M32074-SK21

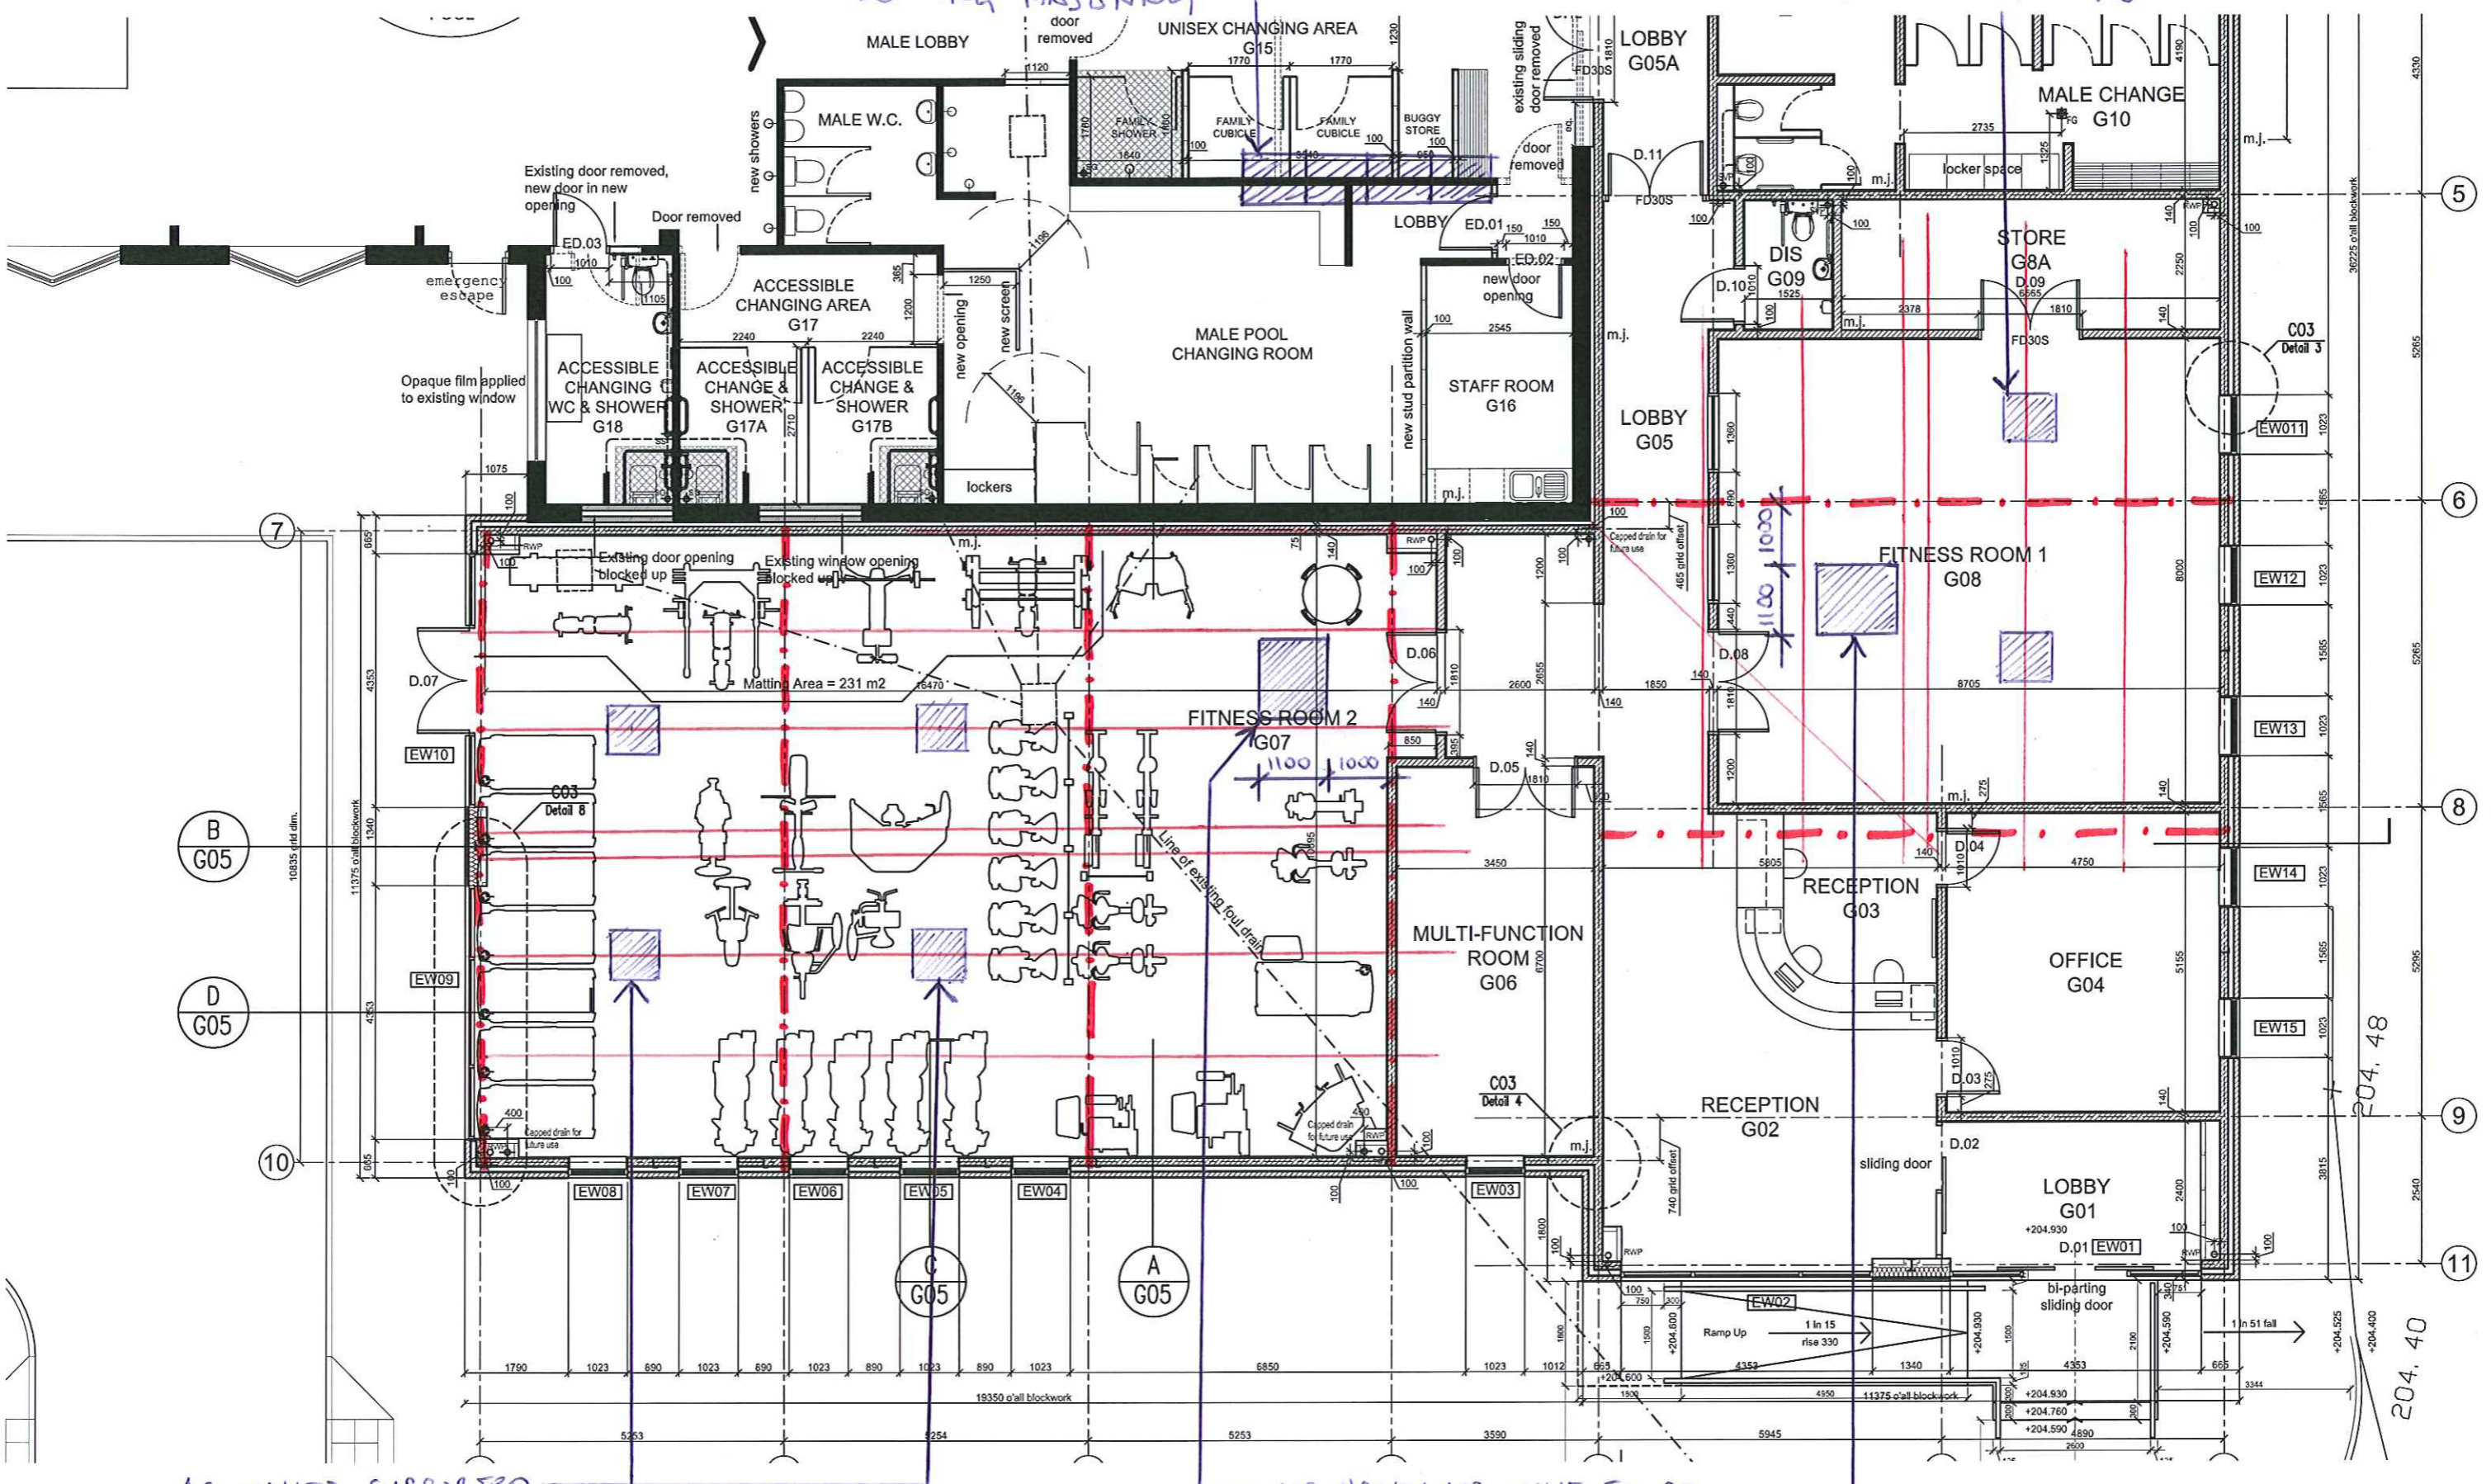
CONDENSING UNITS TO BE SUPPORTED DIRECTLY OFF LOAD-BEARING MASONRY

AC UNITS SUPPORTED FROM 1^{NO} PURLIN. DO NOT SUPPORT FROM AHU PURLINS OR CHS

AC UNITS SUPPORTED FROM 1^{NO} PURLIN. DO NOT SUPPORT FROM AIR HANDLING UNIT PURLINS OR CHS

AIR HANDLING UNIT TO BE SUPPORTED FROM 2^{NO} PURLINS, MAX 1.0 METRE FROM TRUSS. NB. NO OTHER SERVICES TO BE SUPPORTED OFF PURLINS
